5 HNC - 98 Eagle Crest Court, Lillington, NC 27546

# The Holly - LH

10-21-24 - Redlines - JJ

THE HOLLY - LH  
Cover Sheet 'English Country'

**SLAB FOUNDATION PLAN 'ENGLISH COUNTRY'**  
SCALE: 1/8"=1'-0" ON 11x17, 1/4"=1'-0" ON 22x34

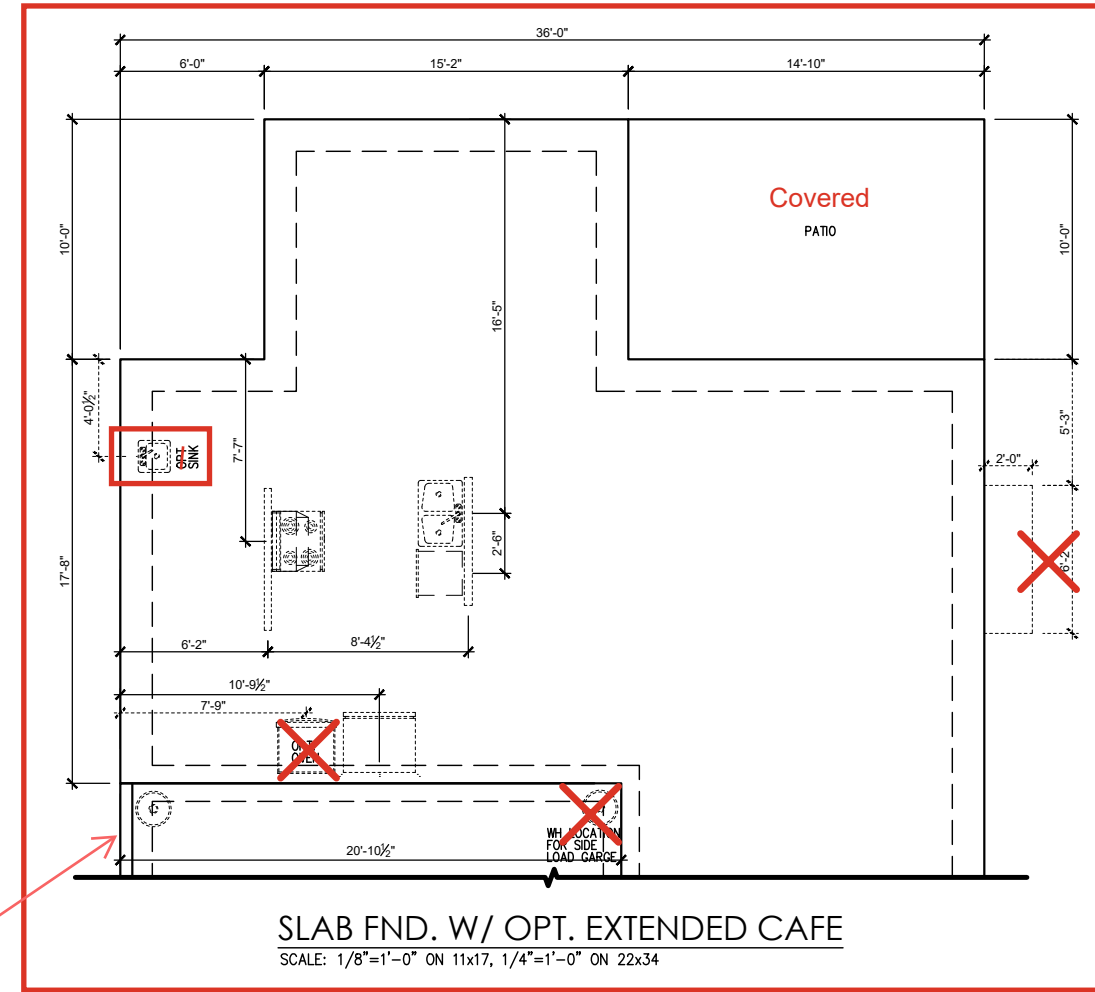
1.1.1c - extended  
cafe, kitchen,  
messy kitchen,  
pantry

2.5c - covered  
patio

17'-8" dim

54'-0" overall dim

20'-4" garage dim

6'-0" porch dim

54'-0" overall dim

38'-0" dim

1.1.1c - pocket  
office, smart door  
delivery and porch  
extension

6'-0" porch dim

**OPT. EXTENDED CAFE**  
SCALE: 1/8"=1'-0" ON 11x17, 1/4"=1'-0" ON 22x34

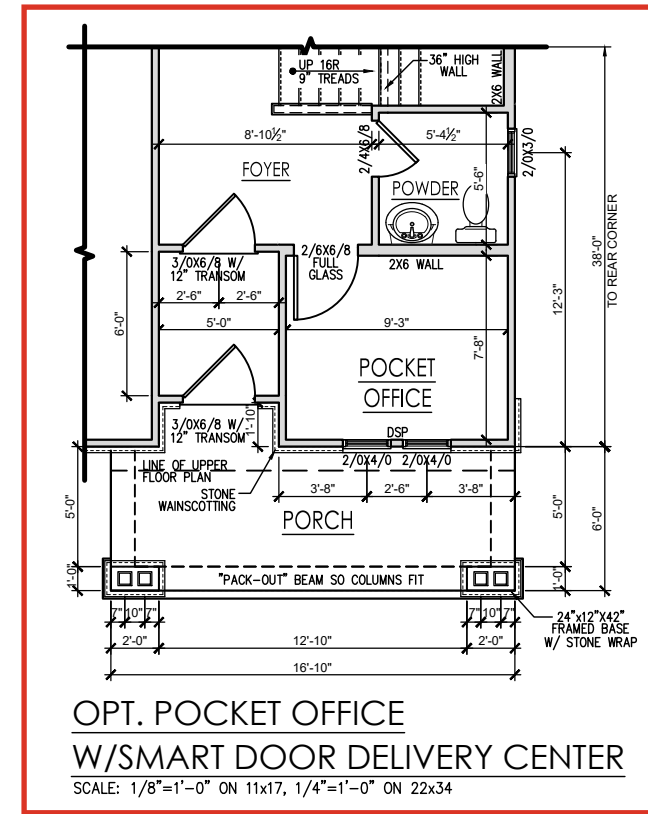
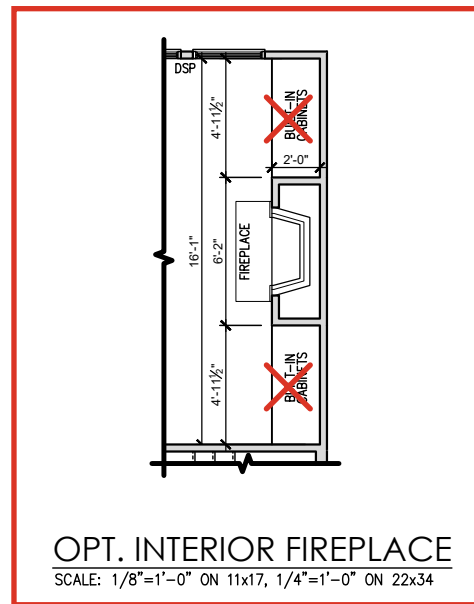
2.5c - covered porch

**SECOND FLOOR PLAN 'ENGLISH COUNTRY'**

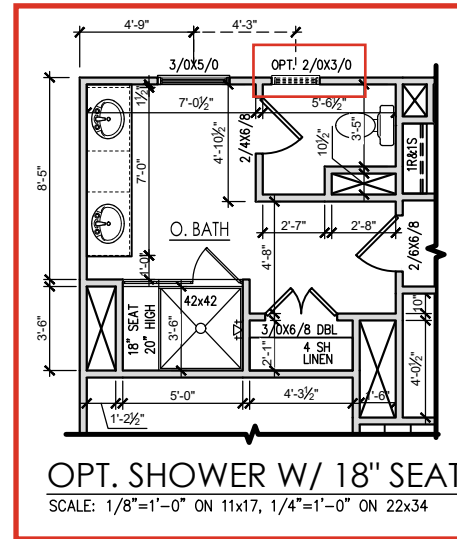
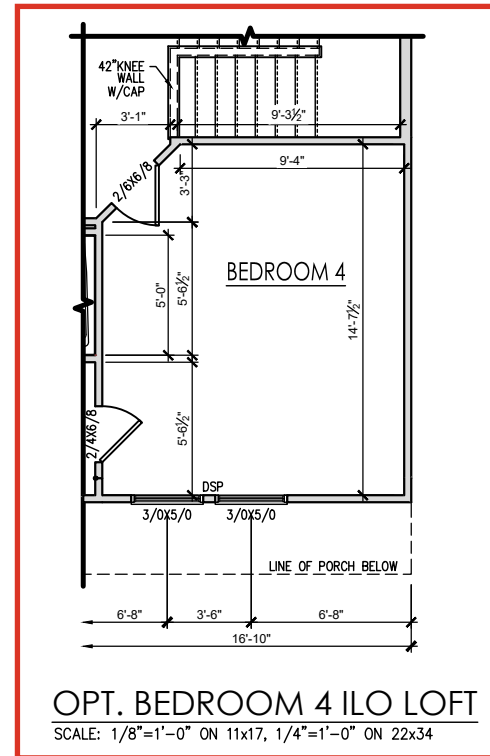
2.2.1c - shower w/ seat

2.2.1c - Bedroom 4 ILO Loft

**RIGHT SIDE ELEVATION 'ENGLISH COUNTRY' (SLAB)**

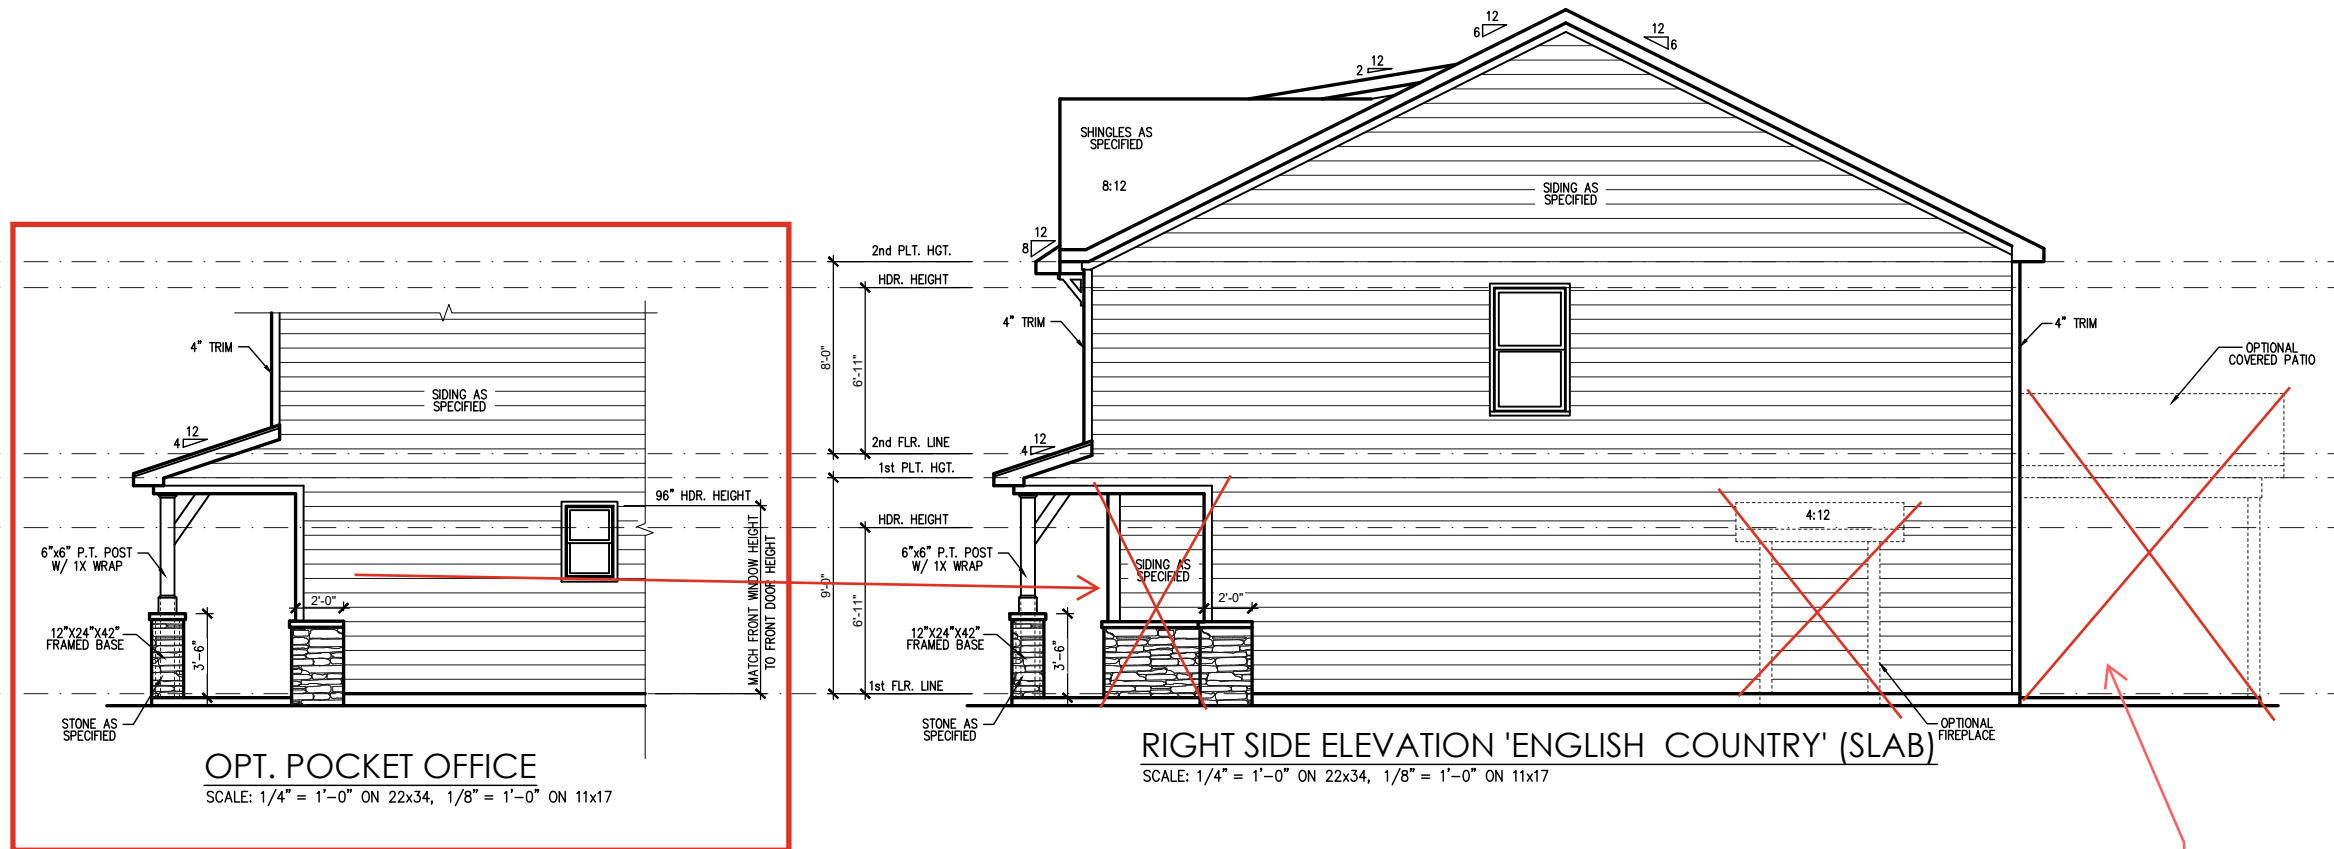
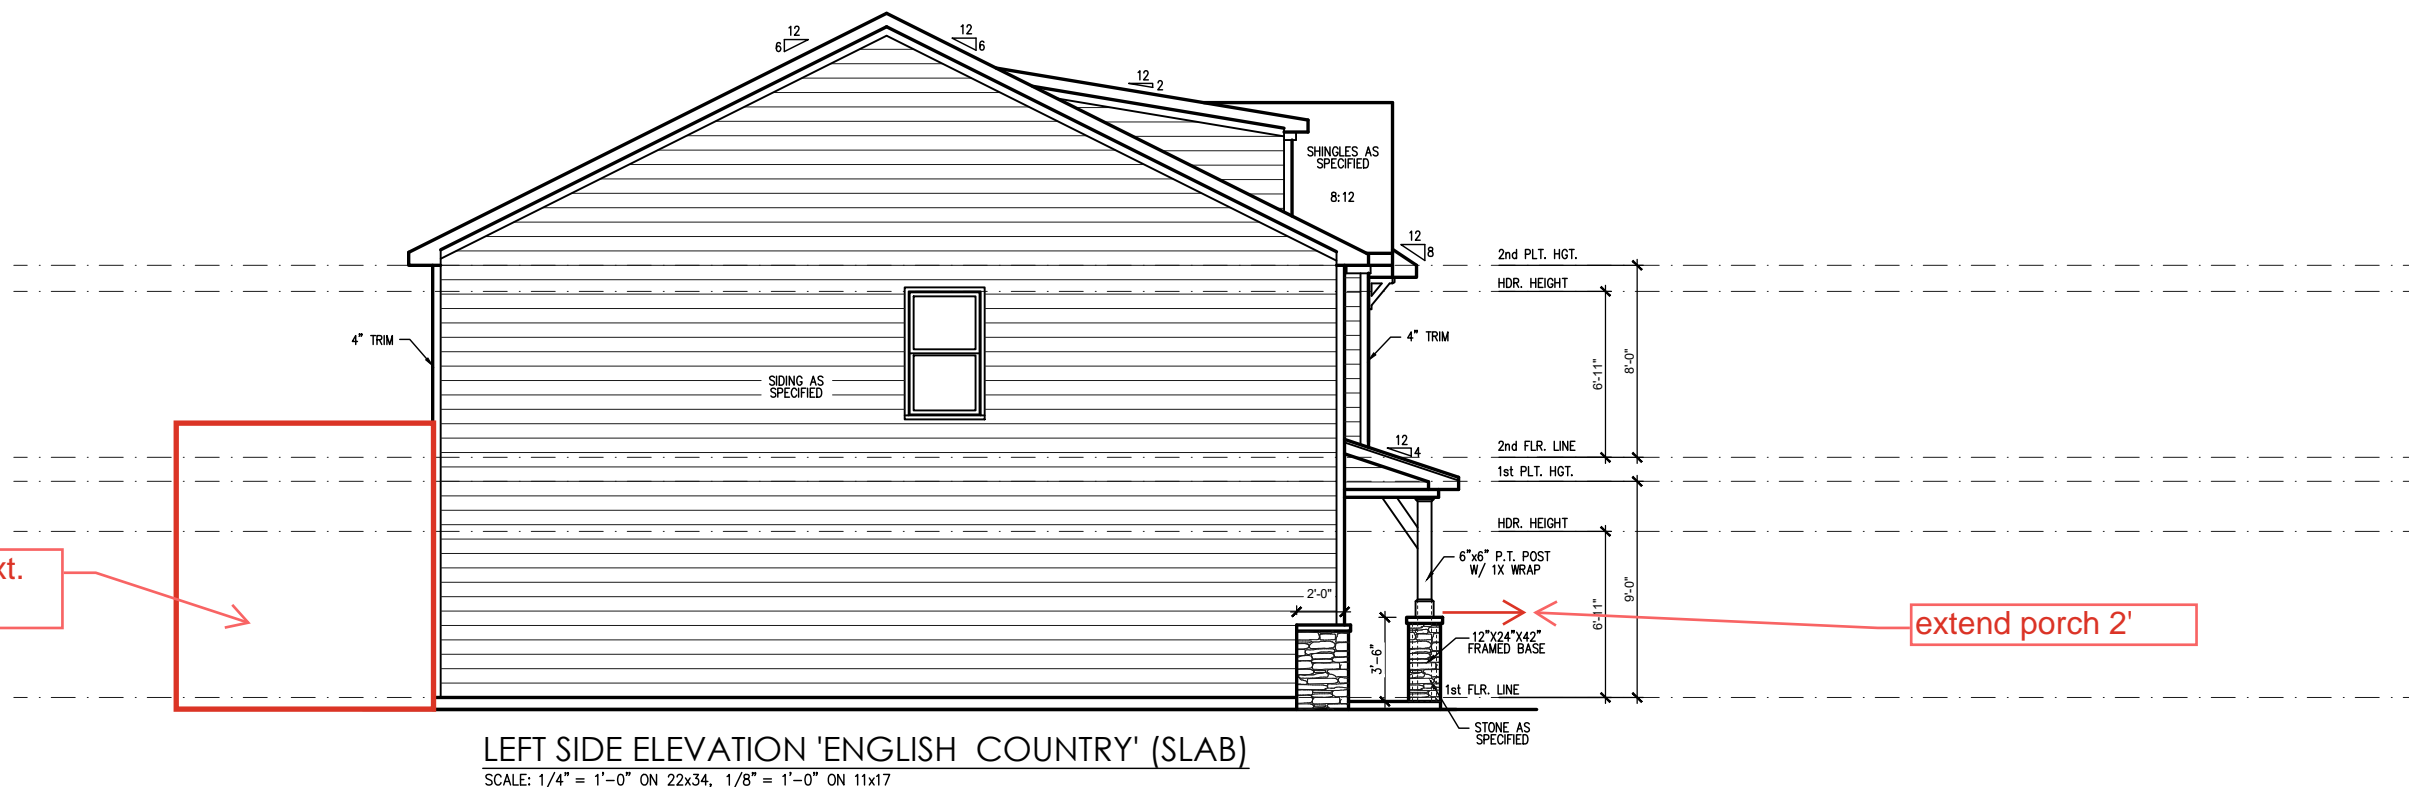
2.5c side of cov. porch

2.5c - side of ext. cafe

extend porch 2'

ENGLISH COUNTRY ROOF PLAN  
 SCALE: 1/4" = 1'-0" ON 22x34, 1/8" = 1'-0" ON 11x17

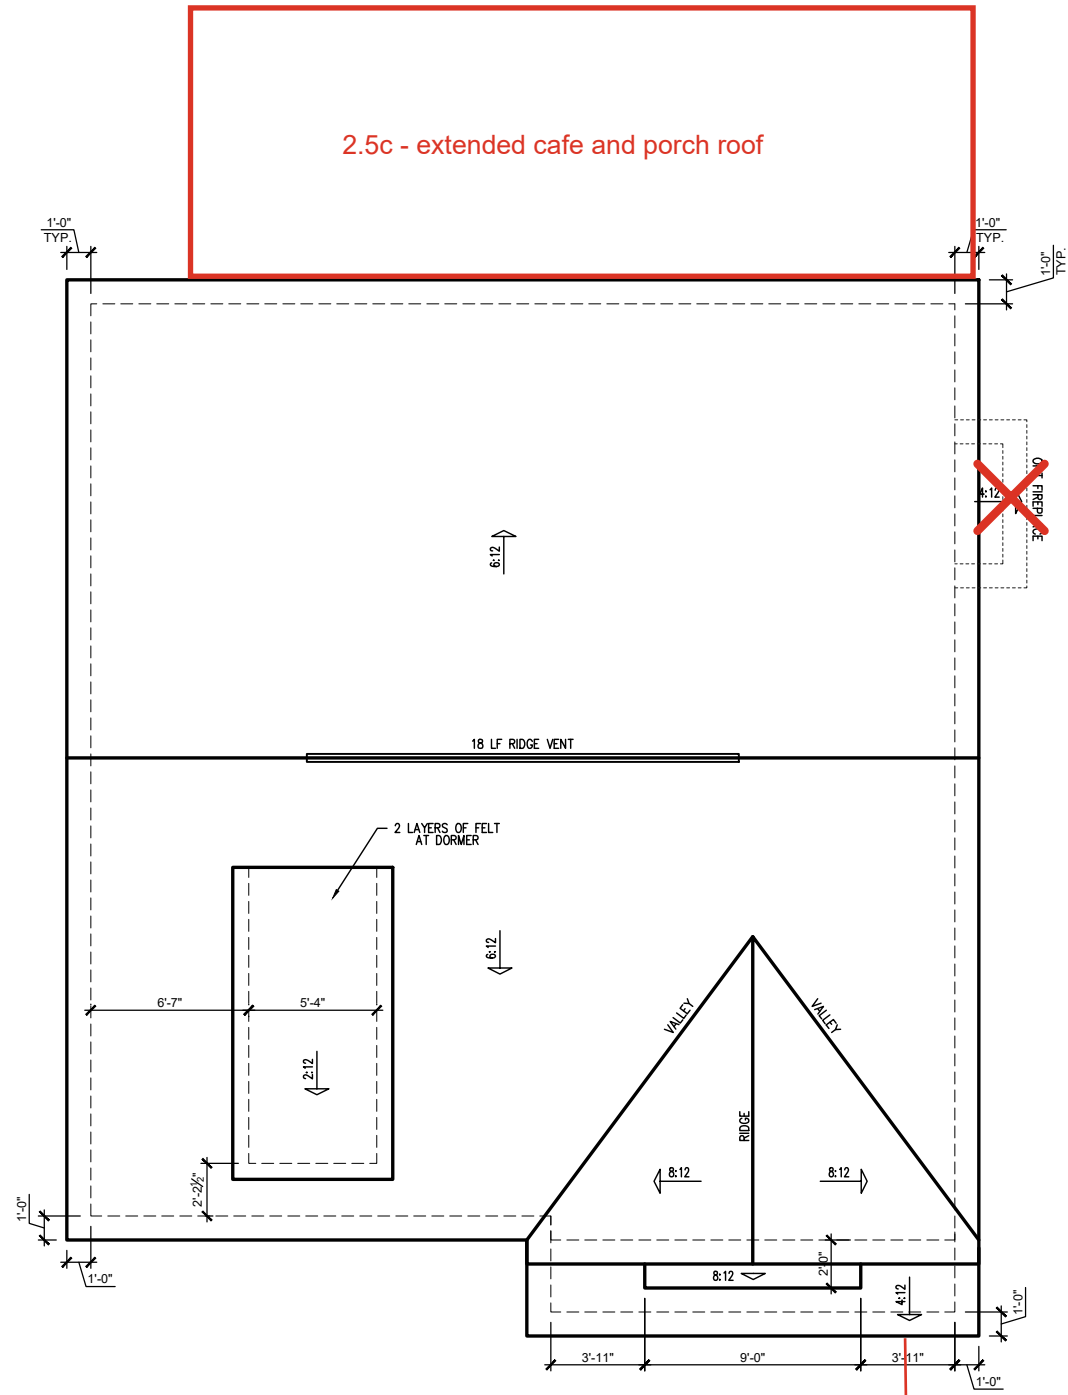
extend porch 2'-0"

**SLAB FOUNDATION PLAN 'ENGLISH COUNTRY'**  
SCALE: 1/8"=1'-0" ON 11x17, 1/4"=1'-0" ON 22x34

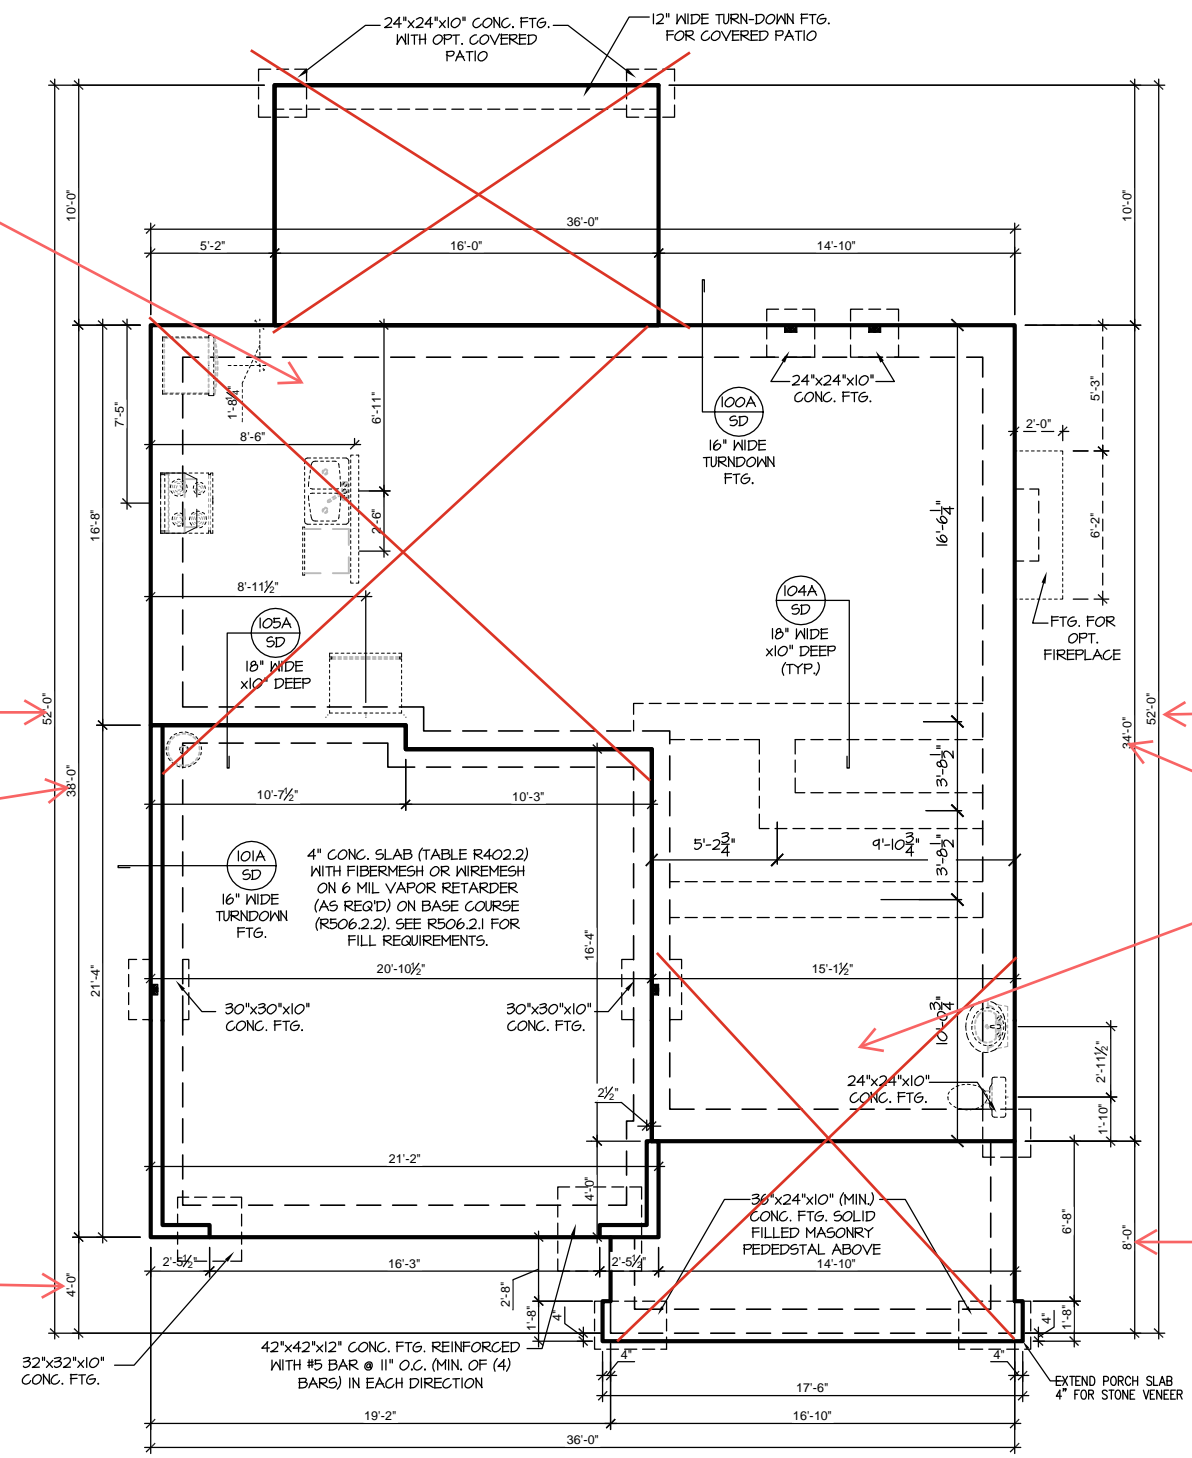
S-1.1.1- Kitchen & garage wall ext cafe

54'-0" overall

38'-0" dim

6'-0" poch dim

54'-0" overall

38'-0" dim

S-1.1.1- Pocket office, smart door delivery and porch ext

6'-0" porch dim
